SUBJECT: RIVER BEND STATION, UNIT 1 – STAFF ASSESSMENT OF FLOODING  
FOCUSED EVALUATION (CAC NO. MF9899)

STAFF ASSESSMENT BY THE OFFICE OF NUCLEAR REACTOR REGULATION

RIVER BEND STATION, UNIT 1

(CAC NO. MF9899)

Figure 3.1-1 River Bend Door Locations (Adapted from Figure 3.1-3 of March 12, 2014, FHRR (ADAMS Accession No. ML14073A647))

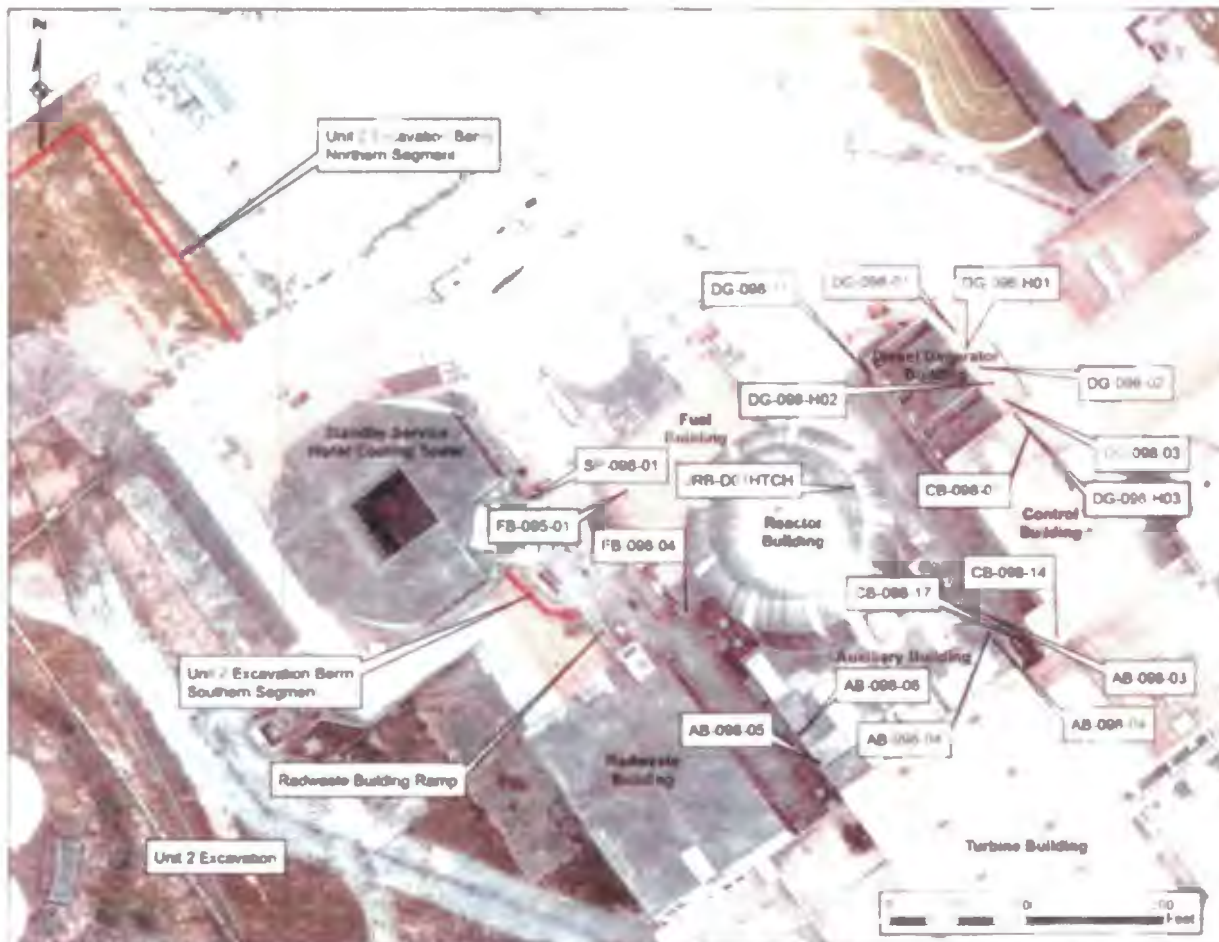
The River Bend FE identified the potential impacts to key SSCs as a result of water ingress due to LIP. The LIP floodwater elevation of 98.3 ft. exceeds the minimum protection elevation of 98 ft. MSL in two areas at the River Bend site, but do not inundate SSCs important to safety. Figure 3.1.1-1 and Figure 3.1.1-2 of this document provide the location of Doors CB-098-17, CB-098-014, AB-098-03, and AB-098-04 that the licensee credits for its conclusion that the LIP event does not inundate SSCs important to safety. These doors are located in the corridor between the control building and auxiliary building where LIP elevations are above 98 ft. MSL.

The licensee's March 12, 2014, FHRR notes that Doors AB-098-03 and AB-098-04 are credited for missile protection and are designed to be airtight to a pressure differential of 3.8 pounds per square inch. In its FE, the licensee performed an evaluation of these doors to provide a flood barrier. The licensee calculated that the maximum leakage rate for doors AB-098-03 and AB-098-04 are 0.72 gallons per minute (gpm) and 1.4 gpm, respectively. The licensee calculated that based on the leakage rates and the door hydrographs the total leakage into the Auxiliary Building is estimated to be 630 gallons, which is within the capabilities of the minimum capacity of 650 gallons of two sump tanks to which the leakage would be directed. The licensee based the minimum capacity of the sump tanks based on procedures that are in place to control the sump tank levels at a maximum of 32 inches.

Based on the design of Doors AB-098-03 and AB-098-04, the capability of the plant's sumps to contain the leakage past these doors in the event of a LIP, and the procedures the licensee has in place to maintain the leak performance characteristics of these doors, the staff concludes that these doors are reliable to maintain key safety functions as described in Appendix B of NEI 16-05, Revision 1.

Figure 3.1.1-2 Critical Door Layout (Adapted from Figure 5.1-2 of March 12, 2014, FHRR)

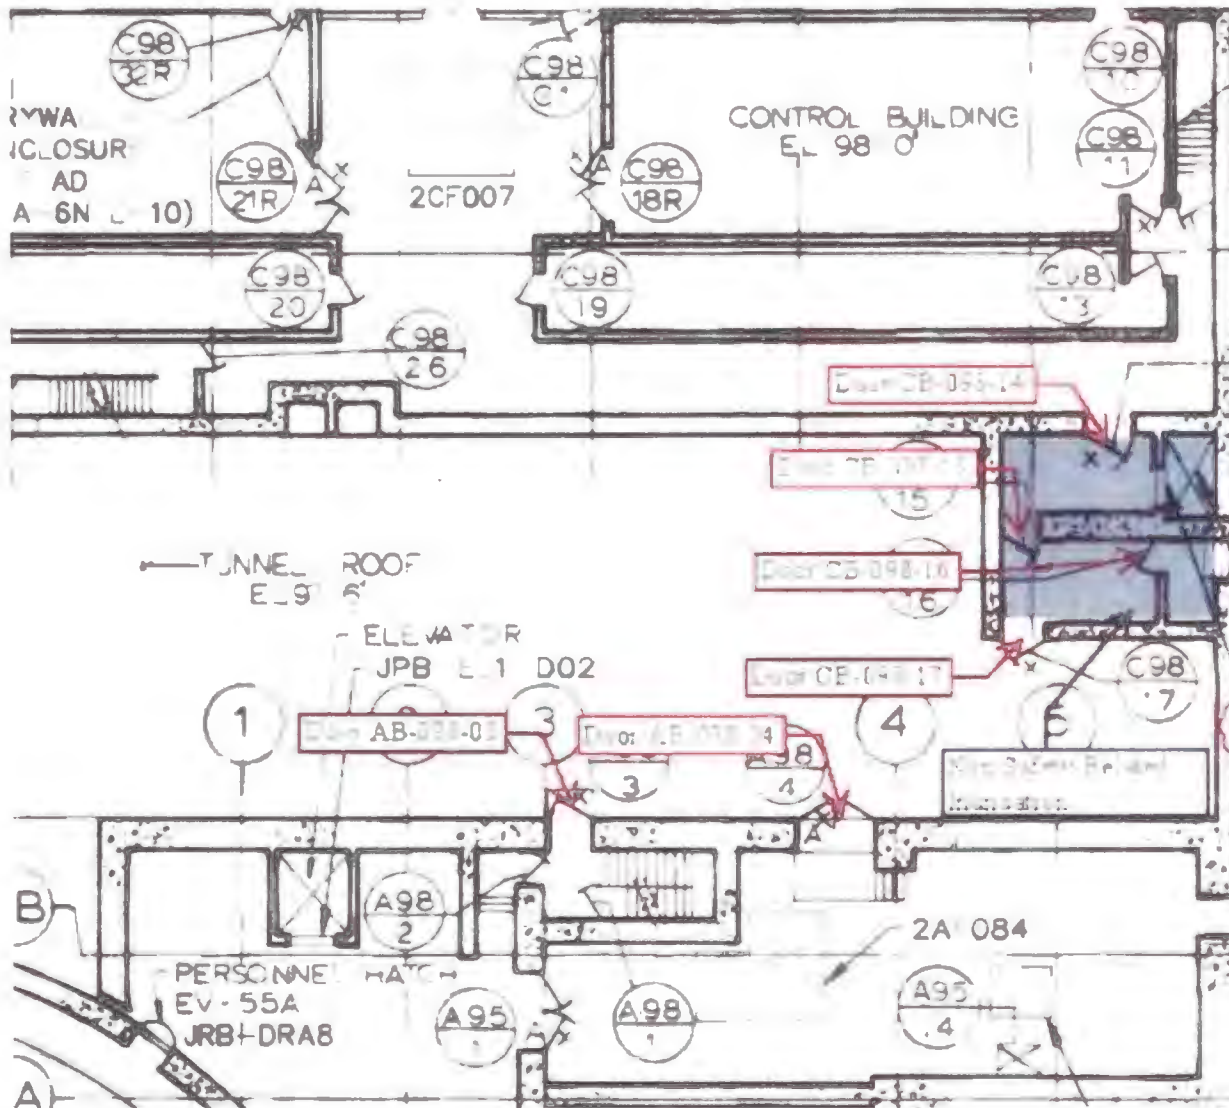
In its FE, the licensee notes that ponding up to 0.3 ft. will occur outside door CB-098-014 after leaking through door CB-098-17. The licensee's FHRR dated March 12, 2014, expands on the discussion of these doors and notes that flood waters penetrating Door CB-098-17 would potentially inundate and penetrate Doors CB-098-016 and CB-098-015. Water penetrating through Door CB-098-16 will enter the bottom of a stairwell, with no impact to SSCs important to safety. Water penetrating Door CB-098-15 will flow into an elevator shaft, with no impact to SSCs important to safety, and would pond against Door CB-098-14, which provides access to SSCs important to safety. The interior area that would be inundated due to leakage through Door CB-098-17 is highlighted in blue in Figure 3.1.1-2.

Door CB-098-014 is a watertight door in accordance with River Bend procedures and is designed to withstand 28 ft. head of water from either side of the door. The staff performed an audit of Specification No. 210.462, Revision 1, "Pressure-tight and Watertight Doors," in accordance with the NRC staff's audit plan dated July 18, 2017 (ADAMS Accession No. ML17192A452), to confirm the criteria used for the design of Door CB-098-014. The staff confirmed that the specification states that watertight doors shall be designed to withstand a 28 ft. head of water from either side of the doors. The specification also states that each watertight door shall be furnished with a compressible gasket designed so that the entire door and frame assembly shall be watertight when the door is closed and subjected to the hydrostatic head.

Based on this door being designed to withstand 28 ft. head of water and experiencing 0.3 ft. head of water due to a LIP event and the procedures the licensee has in place to maintain the leak-tight function of Door CB-098-014, the staff concludes that this door meets the definition of being reliable to maintain key safety functions found in Appendix B of NEI 16-05, Revision 1.
